Peer Review of “Preliminary Design for  
Processing Enhancements at the  
Recycling & Energy Center”  
Prepared by Foth Infrastructure &  
Environment, LLC, January 2019

Ramsey/Washington Recycling & Energy Board  
2785 White Bear Avenue North | Suite 350  
Maplewood, MN 55109  
(651) 266-1199

25218141.00 | March 5, 2019

Exhibit 1. R&E Center Preliminary Design Layout<sup>2</sup>

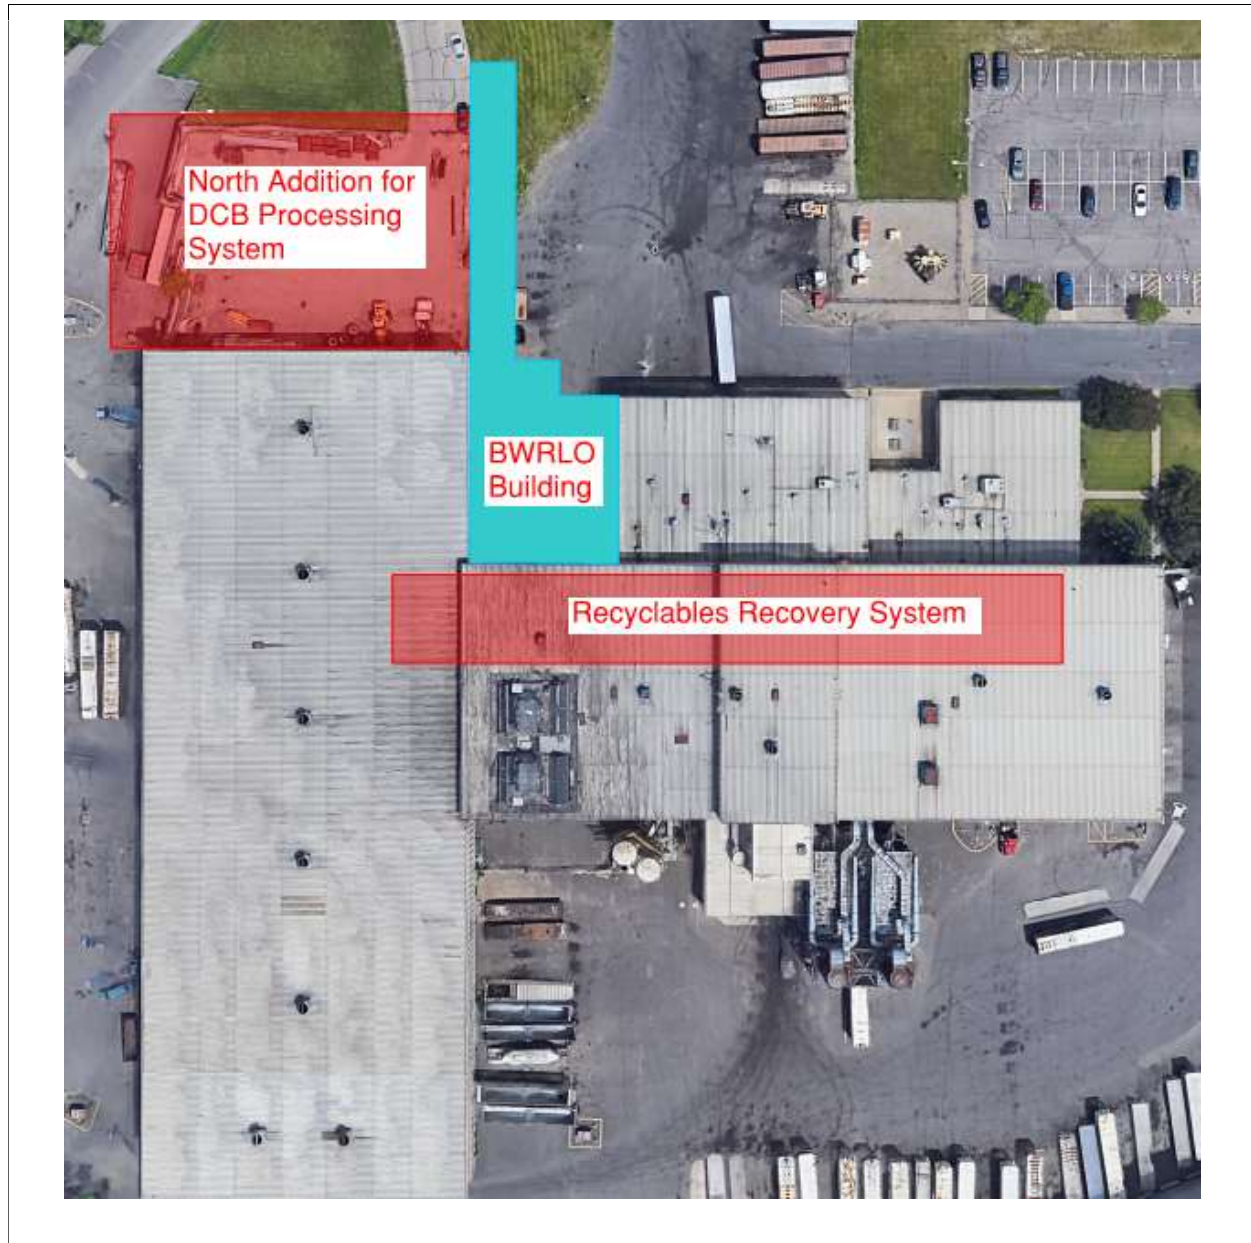
- d. SCS estimates available storage would be approximately 700 to 1,200 tons compared to Foth's estimate of 800 to 1,400 tons. SCS's and Foth's estimates are generally consistent, although SCS's estimate is a little less. The available tip floor storage capacity, including accounting for access needs, should be confirmed for the preliminary design report and refined as the design progresses. Given that the R&E Center can divert to the main RDF tip floor and that the space available for the tip floor is constrained, this probably is not material.

- e. Additional consideration should be given during the final design/specification stage to confirm the capacities of the equipment and address peak disposal rates and available storage, given the relatively limited tipping floor area proposed for the processing system enhancements.

Exhibit 2. Process Flow Diagram for the DCB Processing System

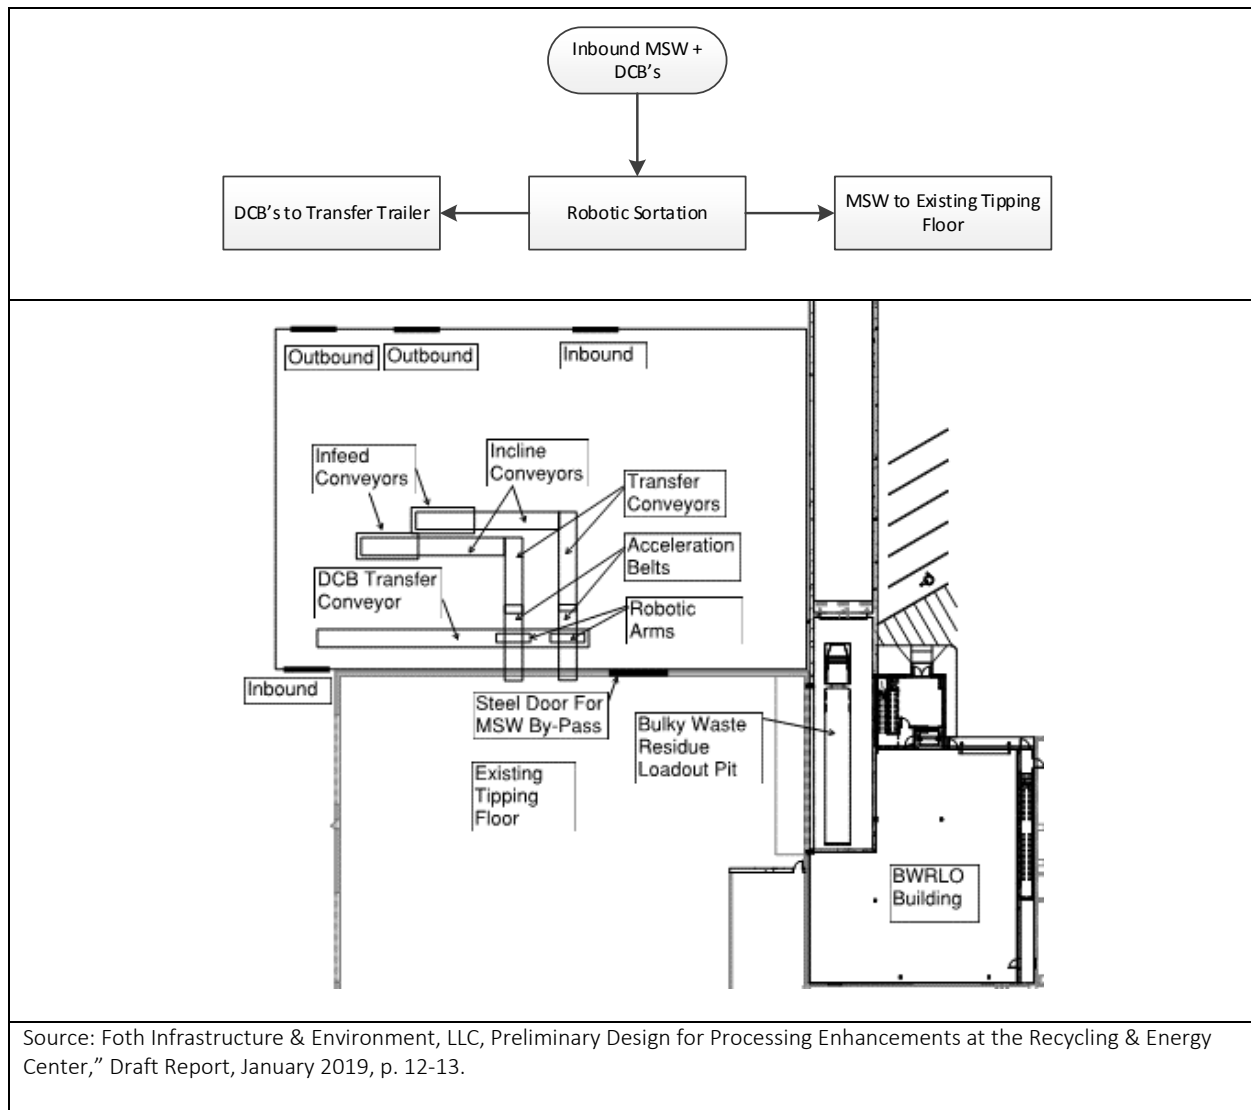
**SCS confirmed the basic process flow calculations developed by Foth. However, the calculation assumes 100 percent uptime of the robotic arms; therefore, some percentage downtime should be considered in the performance specification and design of the system. The robotic arm is one of the more critical components of the proposed system in terms of production performance. As such, some redundancy, either in spare parts or additional arms, should be considered. SCS understands that the robotic arms can be configured with two mechanical claws each, which, if possible, would provide additional redundancy for this critical equipment. If this is the case, SCS recommends that Foth consider specifying additional mechanical claws or have sufficient spare parts in inventory to minimize downtime of the equipment.**

Exhibit 3. Process Flow Diagram for the Recyclables Recovery System

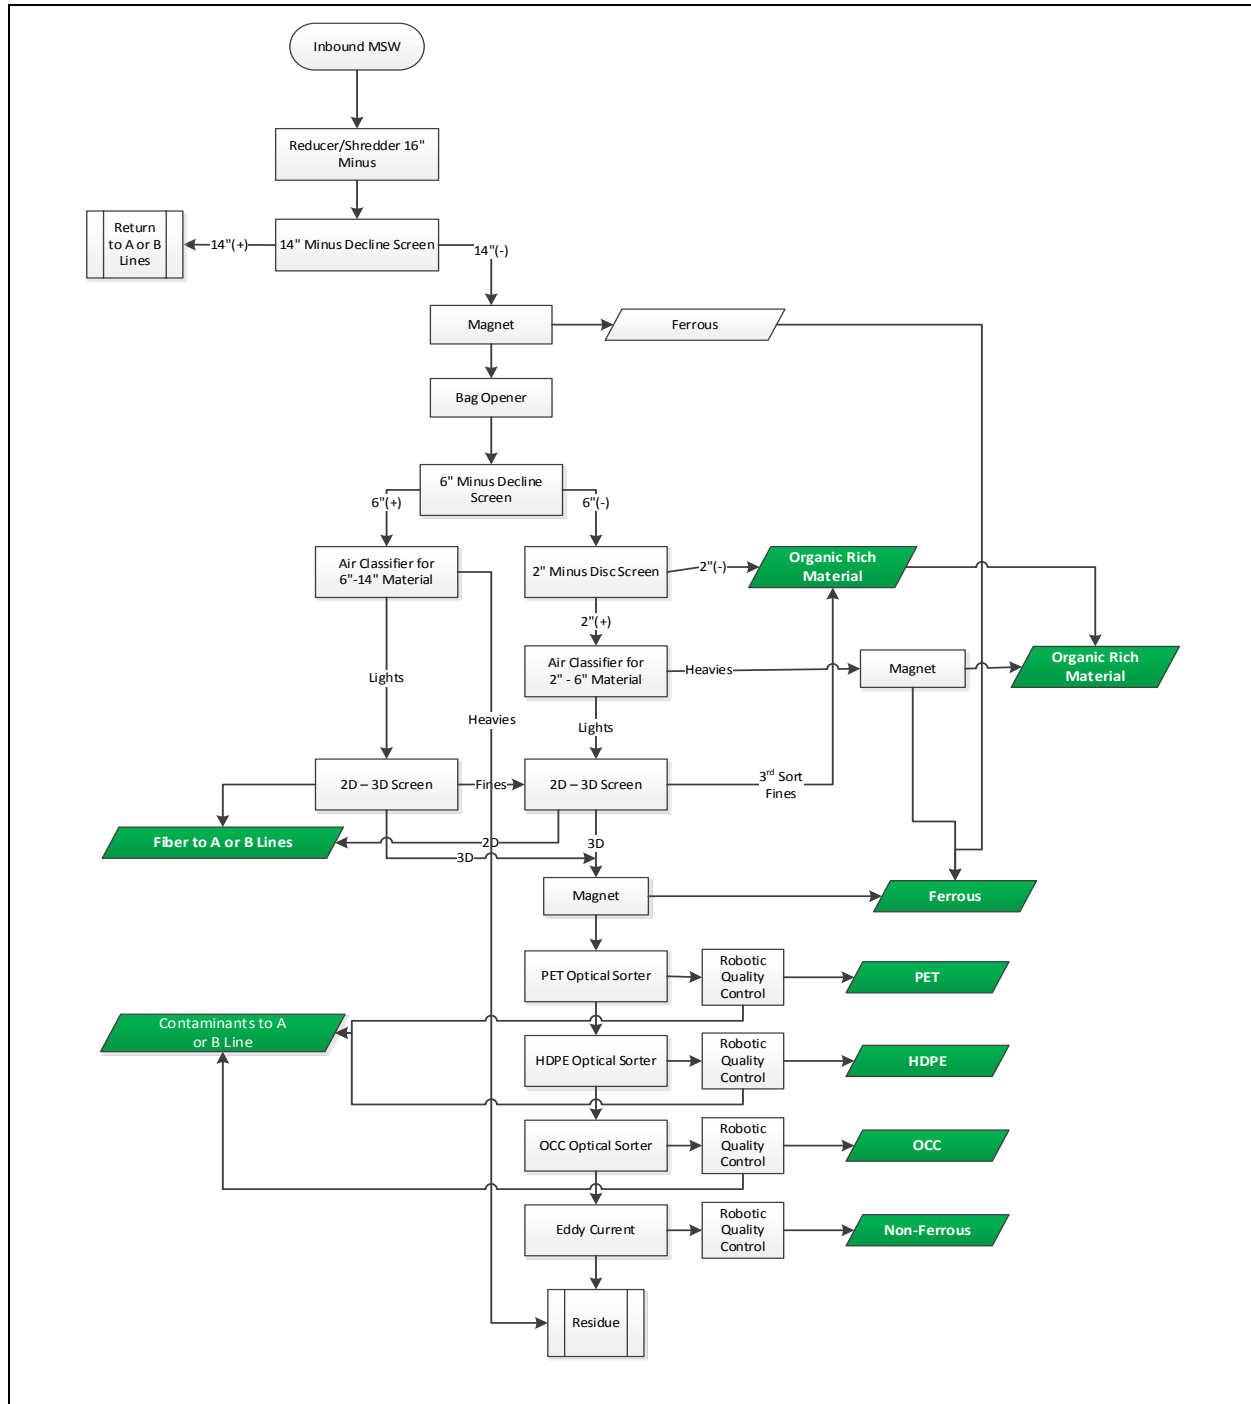
Foth indicates the equipment shown in the preliminary design was selected to minimize manual sorting. The grapple crane operator will be the primary screener for the incoming waste stream to remove unacceptable materials such as bulky items, combustible items (e.g., propane tanks), or other hazardous materials. Given the overall objectives of this mixed waste system, this approach seems reasonable. Contamination will be higher regardless of whether there were manual sorting stages. **However, SCS recommends that Foth consider including sufficient space in the process line to include manual sorting stations in the future if needed to improve the quality of the recyclable materials recovered, or for removal of items that can damage the shredders, screens, conveyors, or other processing equipment. SCS understands that available space to construct the Recyclables Recovery System equipment is limited, so providing this future capability may not be feasible.**

**Foth indicates that the incoming feed through the DCB Processing System removal is designed to process between 45 and 50 tons per hour, based on 4,836 annual processing hours and 225,000 tons per year. SCS double-checked the math on the preliminary process rate and came up with an average 47 tons per hour as a minimum process capacity needed, which is within this range. Foth compares this design rate against the existing A and B RDF Processing Lines, which handle between 217,000 and 242,000 tons per year. However, additional consideration should be given during the final design/specification stage to confirm this capacity and address peak flows and available storage, given the relatively limited tipping floor area proposed for the process system enhancement areas.**
